**ACKNOWLEDGEMENT OF RECEIPT OF REPRESENTATION
DEVELOPMENT APPLICATION NO: 201834426
BLOCK: 9 SECTION: 46 DIVISION: TURNER**

Ordinance Development application File # 14-03-026 Block 9 Section 1611 under (S. Section 66 Turner 1612)

“Housing ACT is looking to replace an ageing three bedroom dwelling built in 1948 at 9 Forbes St, Turner (Block 9, Section 46) with a new multi-unit complex.”

SITE PLAN

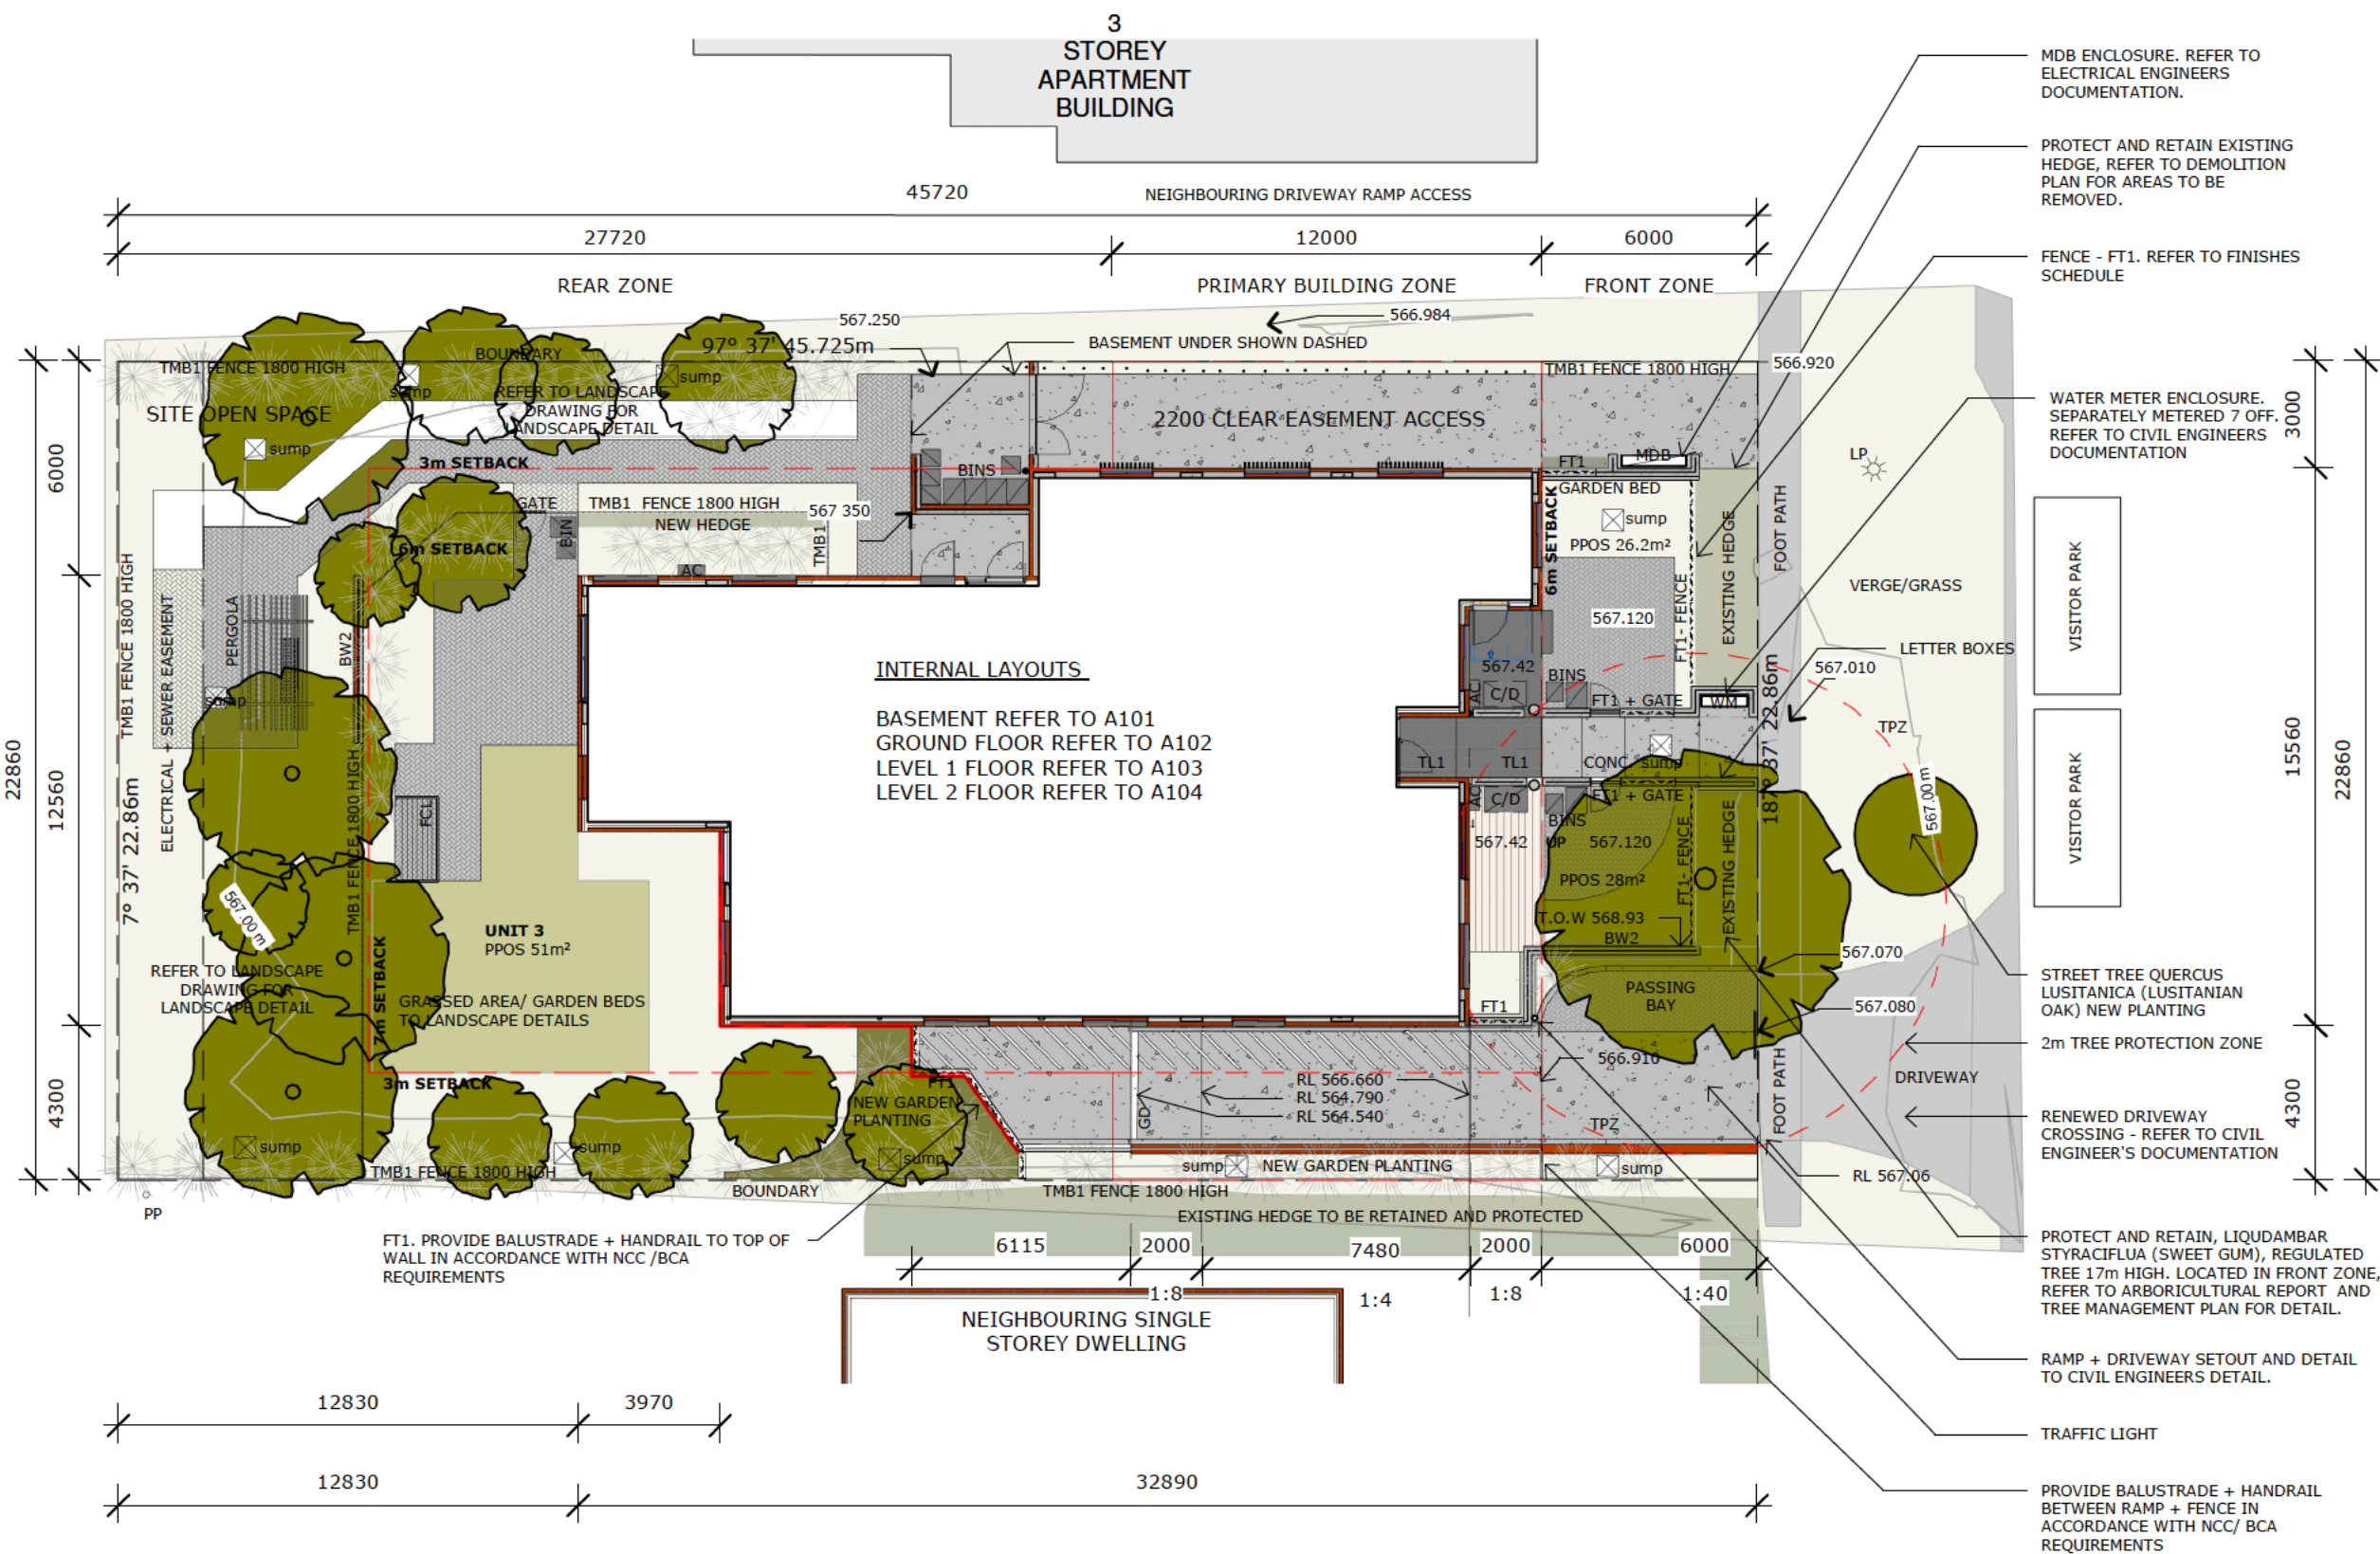
The DA drawings show that there are problems siting a rule compliant driveway and the proposed dwelling structure.

Drawing A061 indicates that the distance between the southern boundary and the building wall is 4.3 metres. R73 requires a separation of 1 metre from an external wall and 1 metre from the boundary. The 1 m from the building in this case is a painted pedestrian path with a handrail. This leave a width of 2.3m for the internal driveway where the minimum design standard specifies a width of 3.0m. A pedestrian walkway is not a driveway and must be clearly delineated if not separated vertically.

In addition, R 75 specifies a width of 5m for not less than 7m from the boundary. The current plan indicates that this may not be achieved for any distance from the boundary as the landscape plan indicates the 1m planting zone continues to the front boundary and the paved area is in the order of 1.6m. It only comes close for a distance of around 5m meaning that a B99 car will be hanging over the footpath when operating a door swipe card.

We note on the Driveway Plan that the kerb at the gutter on the southern boundary remains in the same position but the kerb at the gutter on the northern edge of the driveway is moved north by some 3m, this may impact on Tree 1 on the verge and it appears that this has not been assessed.

- a) Revised site plan, landscape plan and architectural drawings, based on the relevant drawings submitted as part of the application showing:
 - i. the driveway/passing bay reconfigured to improve sightlines and facilitate efficient and safe car movements in the front zone in accordance with the requirements of AS 2890.1 Off-street car parking to the satisfaction of the planning and land authority.

Note: the authority's preference is for the passing bay to be located on the southern side of the driveway.
 - ii. realignment/splaying of the courtyard wall on the northern edge of the driveway to the satisfaction of the planning and land authority to improve sightlines and facilitate car movements within the front zone.
